From: Simon Davis
Sent: 26 August 2014 11:41
To: 'Sophie Hinton'
Cc: Matthew Roe
Subject: RE: Application EG/48/14/DOC - The Barnham Bridge Inn (Drainage Condition)

Project
Barnham Bridge Inn, Barnham
West Sussex, PO22 0ES

Drawing Title
Engineering Layout

Drawing No. 4388/110	Revision T4	Job Ref 4388
-------------------------	----------------	-----------------

External Works and Drainage Layout
(Scale = 1:100)

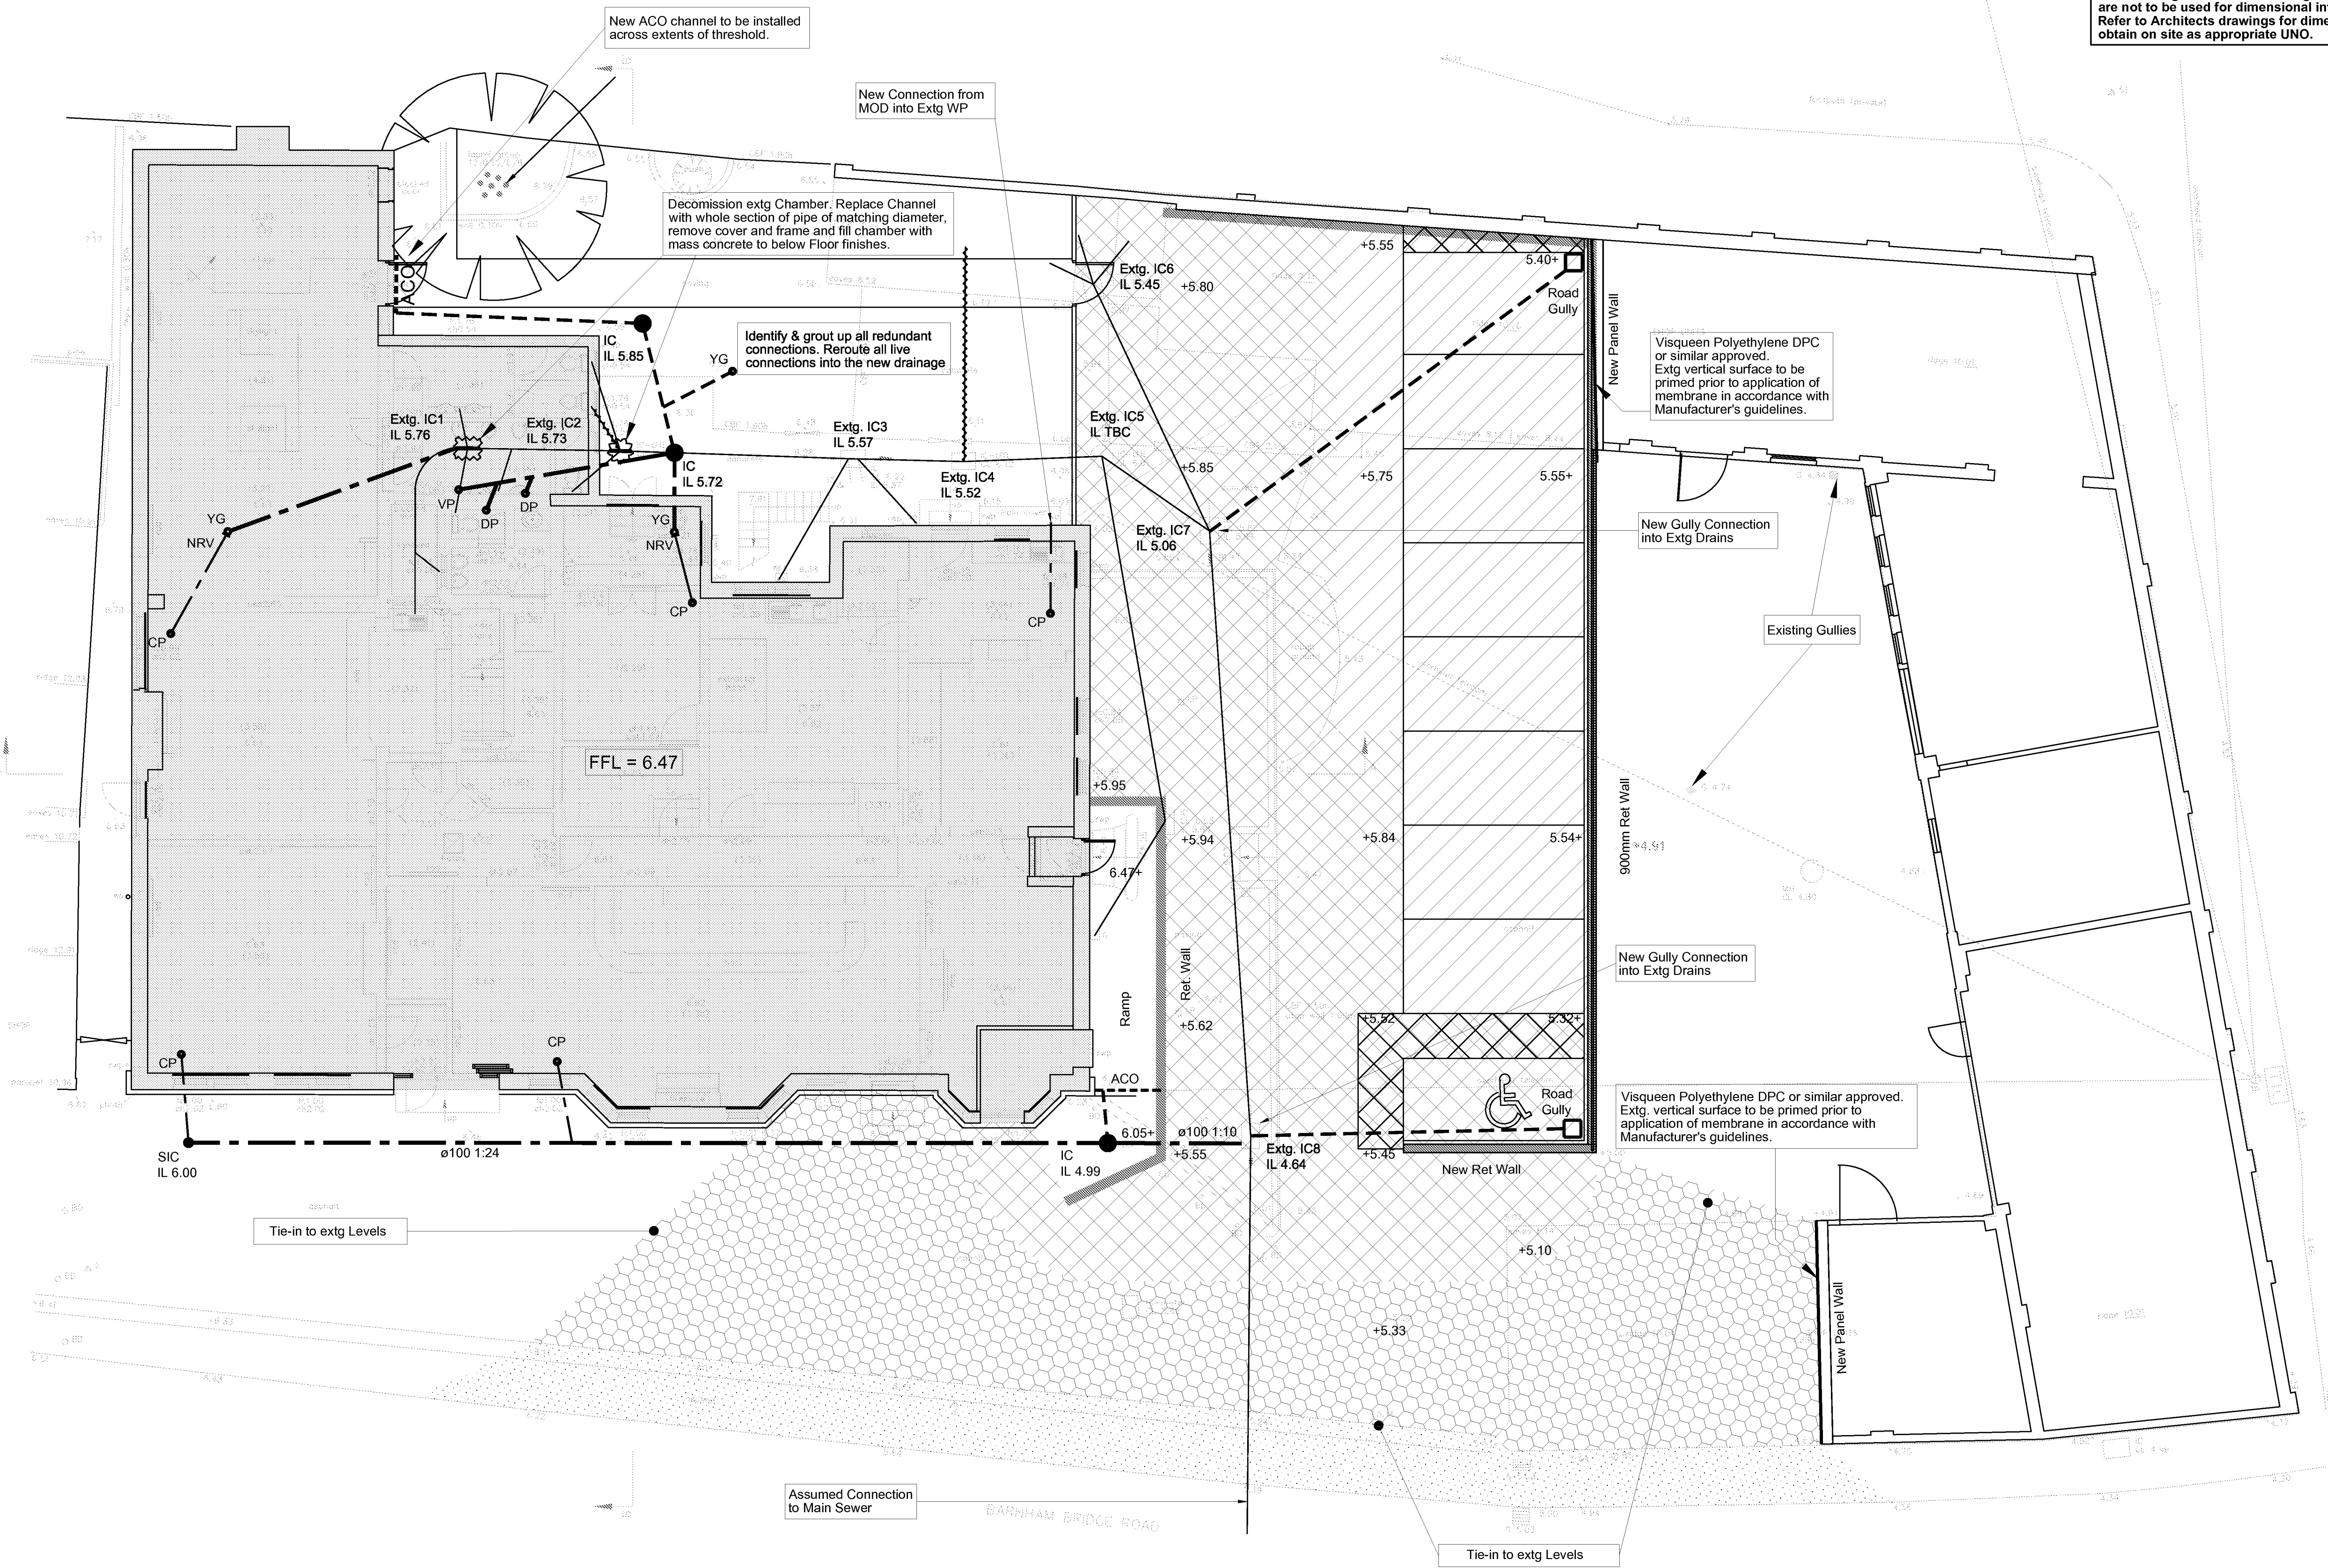
Thank you for approving the details of the condition, however since then there have been some minor alterations to the soak away as the percolation test was unsuccessful.

I have attached the revised plan, please can you confirm this is also acceptable?

I have already discharged the condition. I did so on the basis of the comments I had received from Drainage Engineers and the confirmation from you that the additional gully was already shown on the plans. I can put the new plan on the file but I cannot reissue the decision to refer to it. If you want to have it in writing, you will need to re-apply. I would suggest that you implement the revised plan and I will put a record of this conversation on the file.
